SUBJECT: REQUEST TO REMOVE AN OAK TREE – KENNEDY CLUB FITNESS CENTER

DATE: MARCH 7, 2006

Kennedy Club Fitness
 South River Rd.
 Paso Robles
 CA.

Retaining Wall Elevation
A

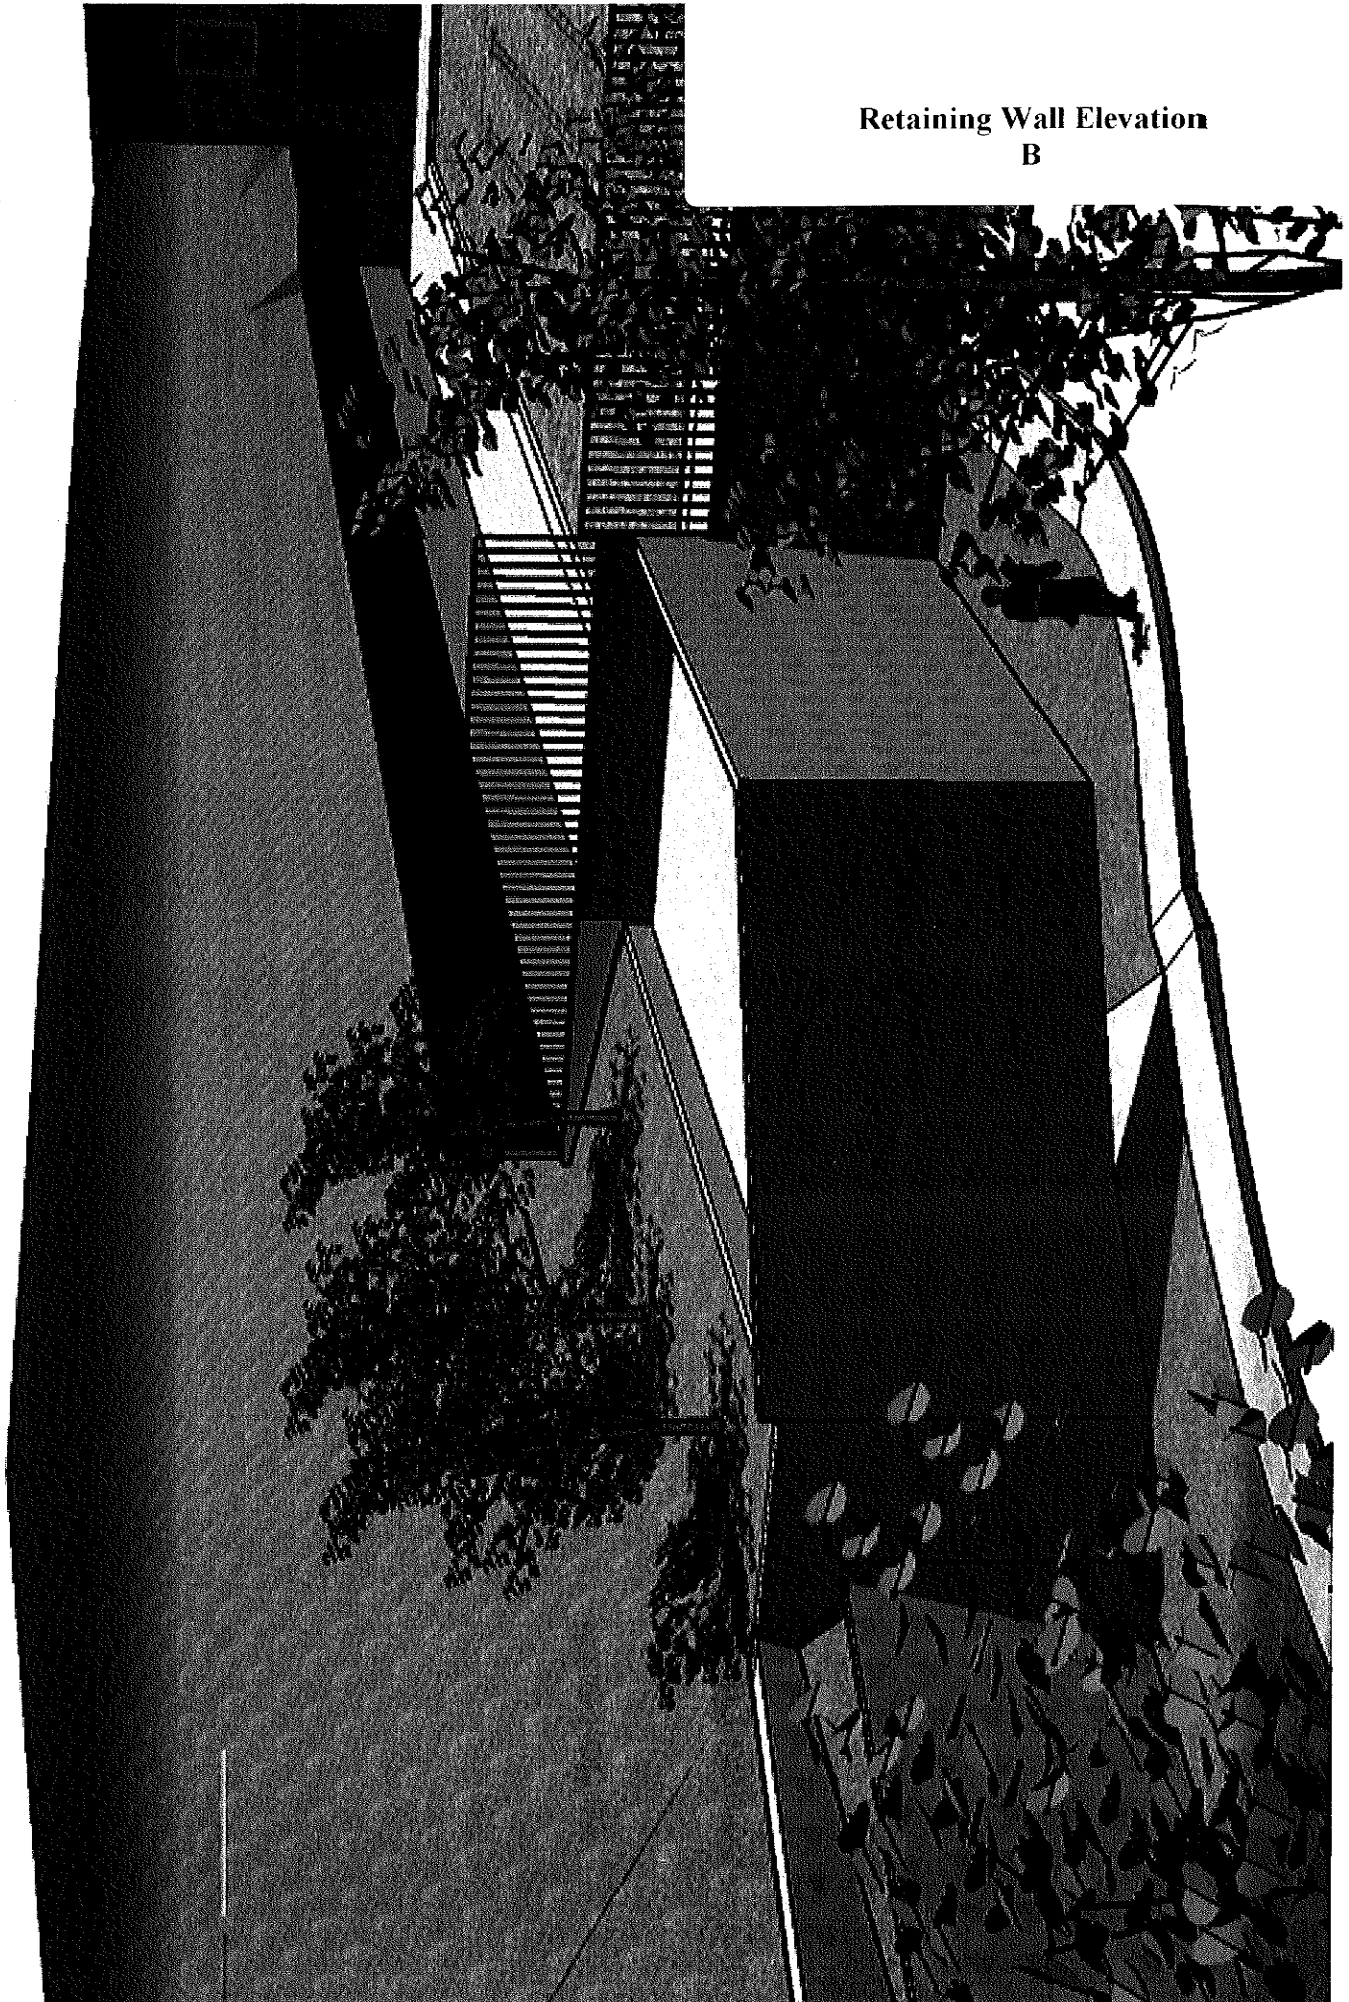
7. The applicant indicates that the existing soil conditions are not suitable to construct the modified retaining wall without removing and re-compacting the uphill soil so that the soil is at a lower angle slope. Removal of the soil and constructing a

retaining wall around the tree to preserve it is estimated to cost \$198,000.

The applicant has shown two possible approaches to the site redesign. The first would involve a 24 foot tall retaining wall (shown in Attachment 3A) which would preserve the oak tree, but which the applicant indicates would be prohibitively costly at \$198,000. The second alternative presented by the applicant (shown in Attachment 3B) is to remove the healthy oak tree, thereby allowing for the equipment room and a lower retaining wall of less economic impact to the project.

- a. Request the applicant provide alternative design options for the site plan and retaining wall system that would preserve the 52-inch oak tree.
- b. Amend, modify or reject the noted option.
